Appendix C : Stakeholder Post-Workshop Design Update Pack

Havant Thicket Reservoir

Phase 7 & 8 Reserved Matters

Realigned Durrants Stream Corridor

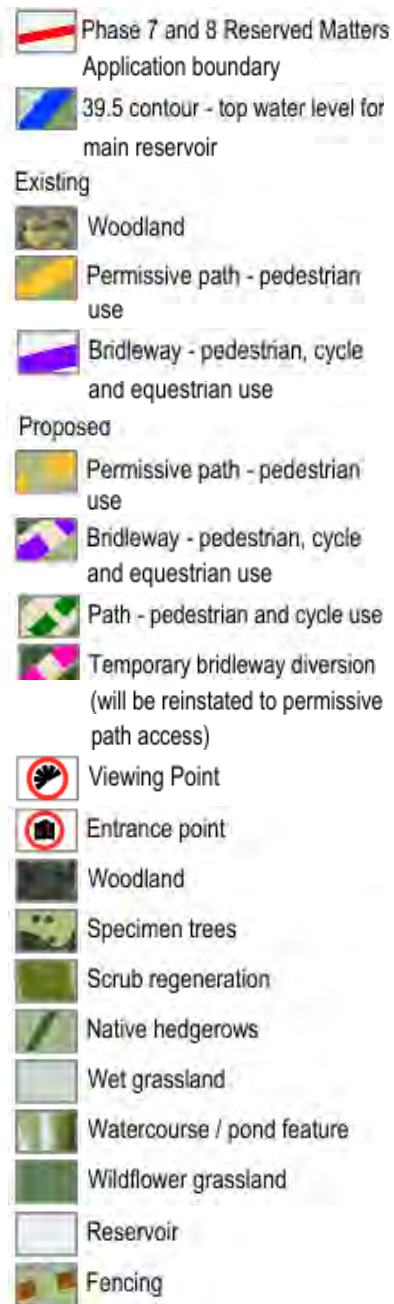
Stakeholder feedback suggested implementing low level flat shelves within new stream channels.

The watercourse improvements connecting the eastern side of the site to Durrants Stream have been designed to wind like a natural river, with backwater features and banks of varying shapes and gradients, including low level flat shelves.

The corridor incorporates habitat enhancement measures, intended to strengthen ecological/hydrological connectivity, improve habitat diversity and provide opportunities for the establishment of more diverse marginal and riparian vegetation.
